SERVICE LETTER

MEL-71-05

POWER PLANT - TRANSMITTAL OF CONTINENTAL AEROSPACE TECHNOLOGIES SIL21-04B

SUBJECT: PURPOSE:	Improved Rocker Cover Gasket, Part No. 668893PENDING APPROVALAnnounce new part number availability and important installation instructionsPENDING APPROVAL	
COMPLIANCE:	CE: When replacing rocker cover gaskets	
MODELS AFFECTED:	Continental Aerospace Technologies new and rebuilt GTSI0520C, D, H, K, L, M, N; I0550D, E, F & L engines converted to crossflow cylinders; I0550G, N, P, R; I0F550G, N, P, R; TSI0520BE; TSI0550A, B, C, E, G, J, K, N; TSI0F550D, J, K & P engines.

Figure 2. Rocker Cover Installation

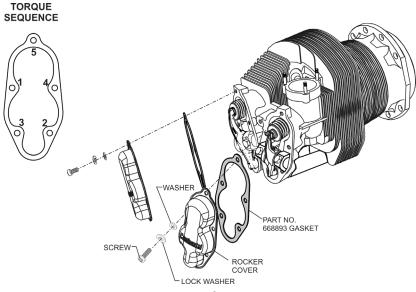
CAUTION: Failure to clean the rocker and cover flanges will cause leaks. Surfaces must be clean and oil-free to seal properly. Applying 55-65 in-lbs. torque to rocker cover fasteners using Rocker Cover Gasket Part No. 668893 will damage the gasket and rocker cover.

- 1. Clean the rocker box (including threaded screw holes) and cover flanges thoroughly with isopropyl alcohol (IPA) or acetone before installing the gasket to remove oil and old gasket residue. Clean the rocker cover screw threads with a wire brush and rinse with IPA or acetone.
- 2. Install rocker cover(s) with new gasket according to instructions in the primary ICA.
- 3. Sparingly apply a thin bead of Continental Part No. 658517 (Loctite® 243) across the rocker cover screw threads according to the manufacturer's instructions. Secure each rocker cover with five screws and torque the screws in an alternating pattern (see Figure 2):

- a. On rockers using gasket Part No. 668893, torque cover screws 20-25 in-lbs.
- b. On rockers using any fiber gasket, torque cover screws 55-60 in-lbs.
